**PCN16-2019 (Change from Standard to Customized JEDEC Trays)  
CMV20000 & CMV50000 product family**

**Affected Devices / Product Family: CMV20000 & CMV50000**

### Comparison

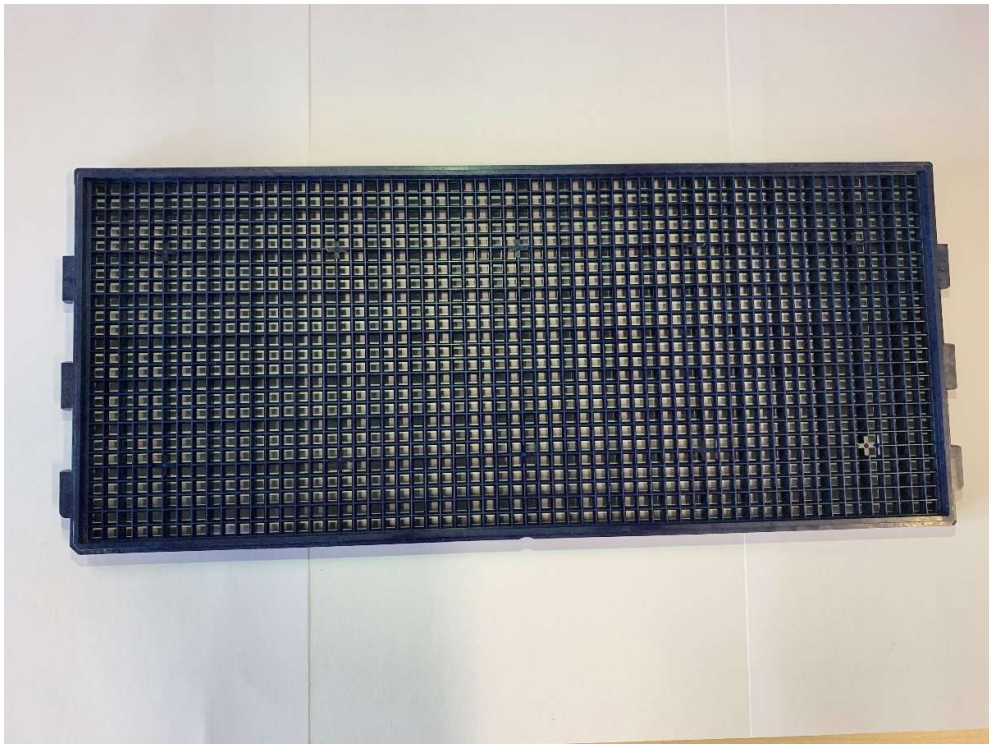
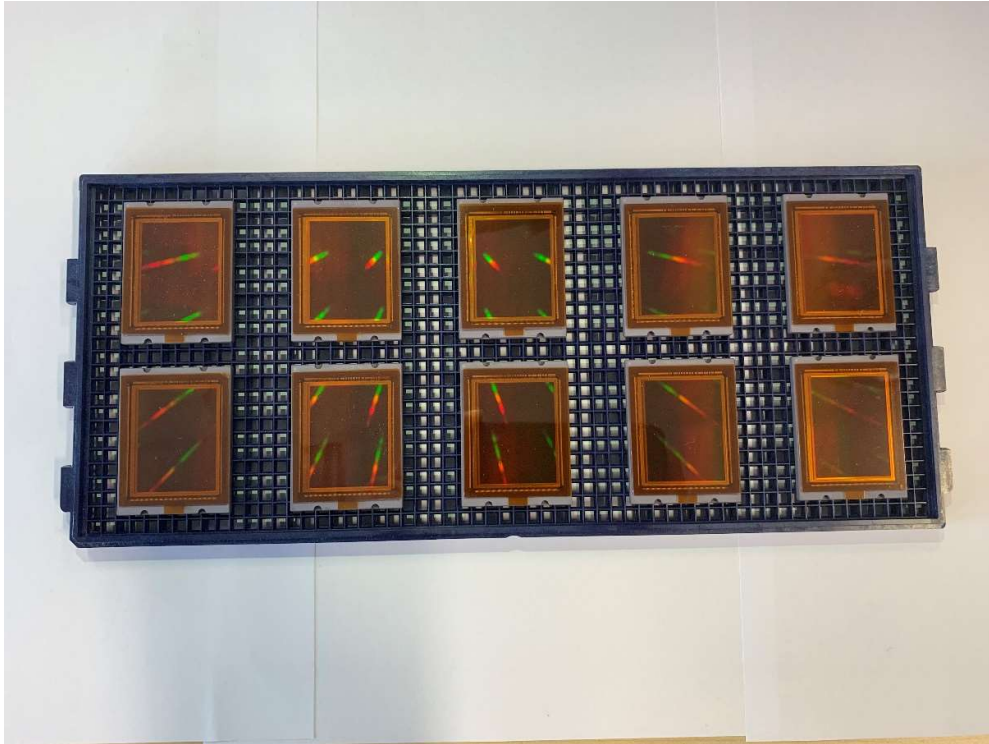
Please be informed that ams AG is changing the JEDEC trays for the packing of the CMV20000 & CMV50000 image sensor families. This change is not affecting any product specifications, only the packing form.

To avoid potential transport markings, ams will introduce customized JEDEC trays for the CMV20000 & CMV50000 product family.

The outside packing will change. A double-waved carton box will be used to ensure more stability during shipment. Moreover, the customized tray has an improved maximum baking temperature. From up to 50 degrees Celsius for the standard tray, the maximum baking temperature for the customized tray is up to 150 degrees Celsius.
